## Albemarle County Planning Commission Staff Report

<b>Project Name:</b> ZMA202400004 Flow Steep Slopes Amendment	<b>Staff:</b> Rebecca Ragsdale, Planning Manager
<b>Planning Commission Hearing:</b> February 11, 2025	<b>Board of Supervisors Public Hearing:</b> To be Scheduled
<b>Owners:</b> Flow Mercedes and Toyota	<b>Applicant:</b> Kelsey Schlein, Shimp Engineering
<b>Acreage:</b> 0.80 acres of Steep Slopes, 9.61 total acreage of three parcels	<b>Rezone from:</b> Preserved to Managed Steep Slopes; Remove existing proffers (ZMA201600023)
<b>Tax Map Parcels (TMP):</b> 07800000001400, 078000000014A0, 078000000014E0	<b>Location:</b> 1357 Richmond Road
<b>School Districts:</b> Stone Robinson (Elementary); Burley (Middle School); Monticello (High School)	<b>Magisterial District:</b> Scottsville
<b>DA (Development Area):</b> Pantops	<b>Comp. Plan Designation:</b> Commercial Mixed Use, Community Mixed Use, and Parks & Green Systems.
<b>Character of Property:</b> The subject area lies at the rear of the properties fronting on Route 250, which are occupied by parking uses associated with the vehicle sales and service use.	<b>Use of Surrounding Properties:</b> The surrounding properties al

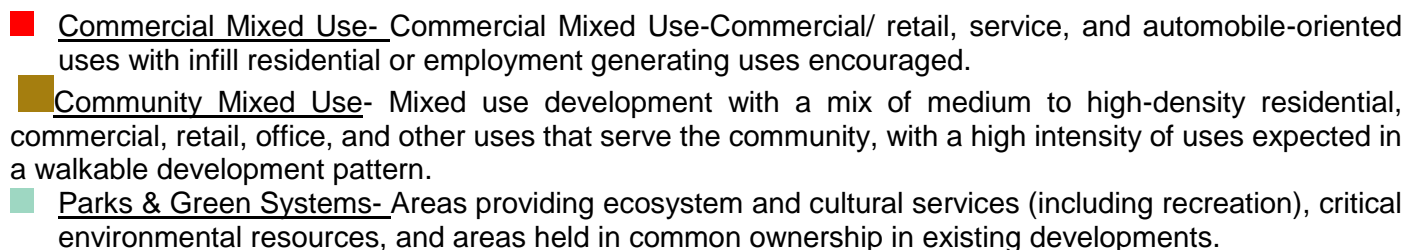
This rezoning seeks to rezone all Preserved Slopes on the subject parcels to Managed Slopes as proposed in Attachment 2 and shown below. A concept plan for those areas is not provided but the applicant indicates the redesignation would allow future expansion of the auto dealerships for parking and potentially car wash facilities.

Staff believes that the slopes overwhelmingly meet the characteristics of Preserved Steep Slopes as opposed Managed Steep Slopes on parcels 07800000001400 and 078000000014E0. Therefore, staff recommends denial of ZMA202400004. However, staff acknowledges portions of Preserved Slopes on 078000000014A0 are around a previously approved stormwater basin. With a revised concept plan demonstrating only that limited area would be impacted, staff could support that designation changing to Managed Slopes on only that portion of the parcel that drains to the stormwater basin.

1. Existing slopes present more characteristics of Preserved Slopes than Managed Slopes.
2. The rezoning proposes to remove a 2.47 acre preservation area proffered with ZMA201600023 that provides protection for an intermittent stream.
